**Byers Gill Solar**  
**EN010139**

# 8.12 Comments on Deadline 2 Submissions including Written Representations and Responses to ExQ1

Deadline 3 – September 2024

Figure 1 Construction dust receptors in DCC administrative area

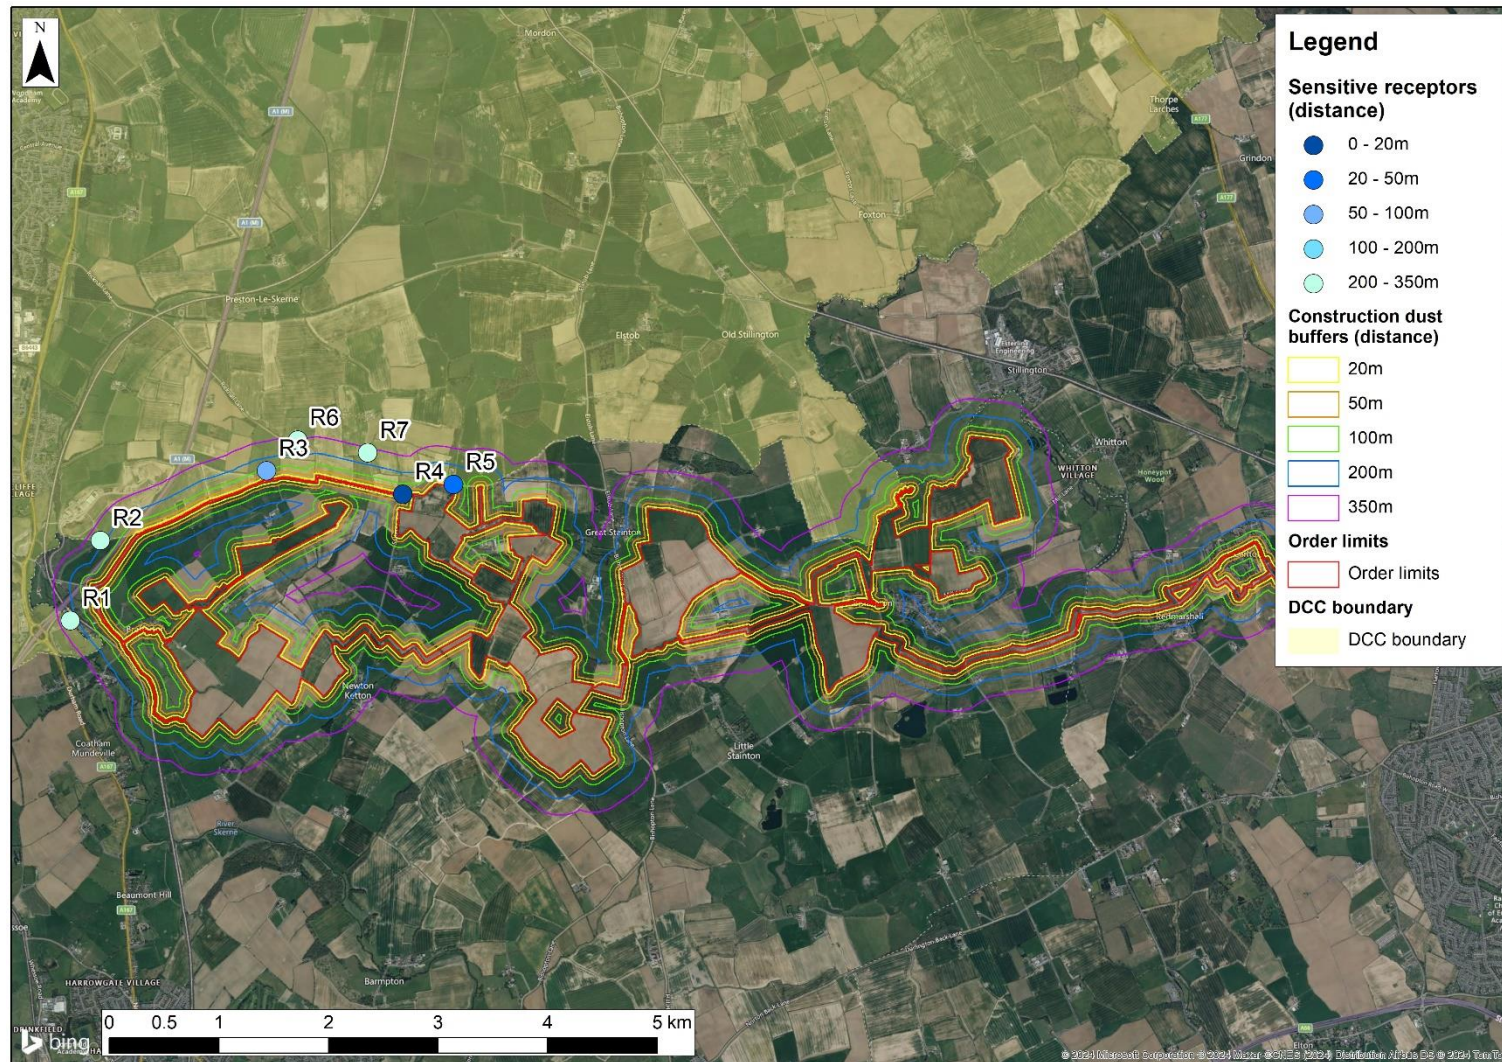
- 4.4.2. Under reference 5.85 of the DCC Local Impact report (LIR), the Applicant committed at Deadline 2 [REP2-008] to providing a revised figure of a construction dust buffer to enable DCC to identify which receptors sensitive to air quality lie within the DCC boundary. The figures (and supporting receptor table) are provided as Appendix A to this document and have been shared directly with DCC as part of ongoing SoCG discussions.

The following figures show the receptors assessed in the air quality construction dust assessment that are located in County Durham. These are listed below to aid understanding, as requested by DCC in their LIR [REP1-025]
